File No. POH-2011-00228

Regional General Permit Verification

ULEHAWA CHANNEL OUTLET
MAINTENANCE DREDGING
EWA BEACH, OAHU

ULEHAWA CHANNEL OUTLET

FIGURE 8

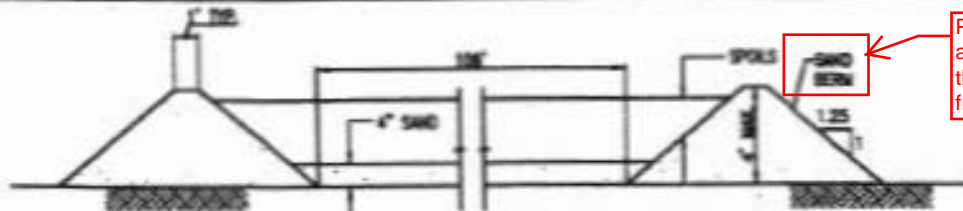
Please provide sand source and quality, the elevation of the MHHW, and its distance from the MHHW

FIGURE 9 ULEHAWA CHANNEL OUTLET BMP/DEWATERING DETAILS

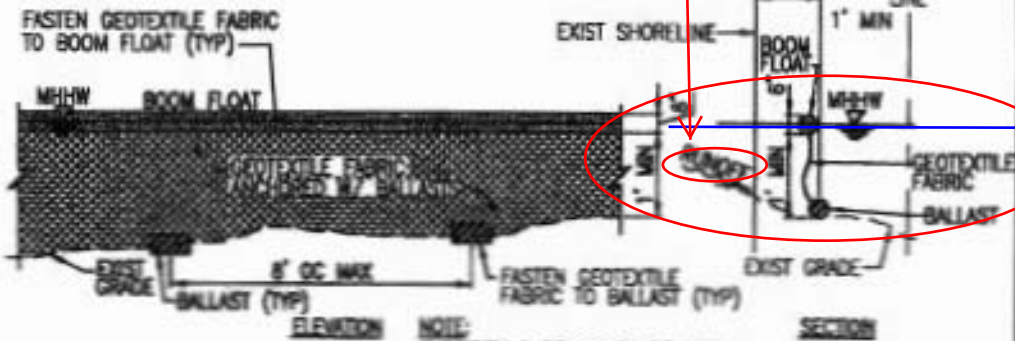
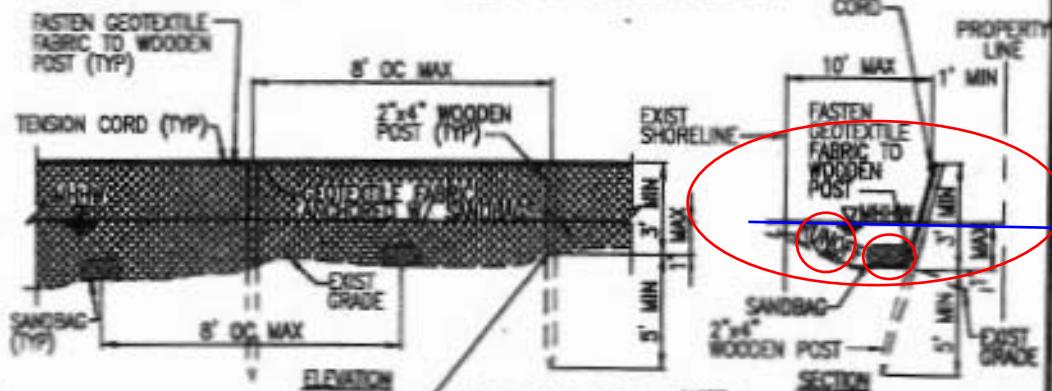
Runoff from dredged spoils dewatering site?
